MEMORANDUM

From:	Chief Officer, Environment & Technical	To:	Chief Officer Planning & Regulatory
Our Ref:	ET/DC/MM/P/2023/0221	FAO:	Gwyn Humphreys
Date:	5 th December 2023	Your Ref:	P/2023/0221

Land South Of Berse Road, Caego, Wrexham, LL11 6TP Erection of 47 dwellings and associated infrastructure

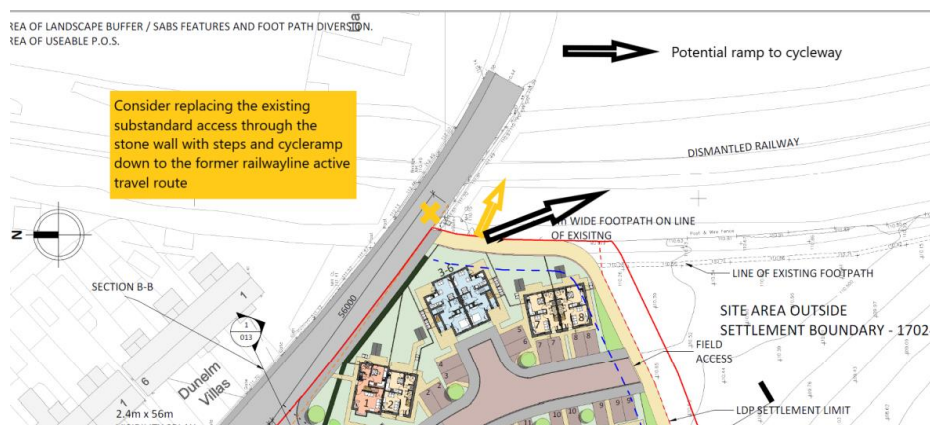
Can the applicant coordinate with WCBC's Active Travel Lead, Gwen Thomas at gwen.thomas@wrexham.gov.uk please to agree adjustments/improvements to the active travel route to link the site access with the former railway active travel route to the proposed path, together with provision of some lighting improvements locally to the ramp, track and bridge. Once installed can the existing substandard access in the stone wall of the bridge be blocked up, all as noted on the marked up plan below? This would facilitate direct active travel links between the site and city center, avoiding some very congested roads. If there is a more favourable location for the link to the cycle track where gradients are improved, we are happy to agree this on site with the applicant.
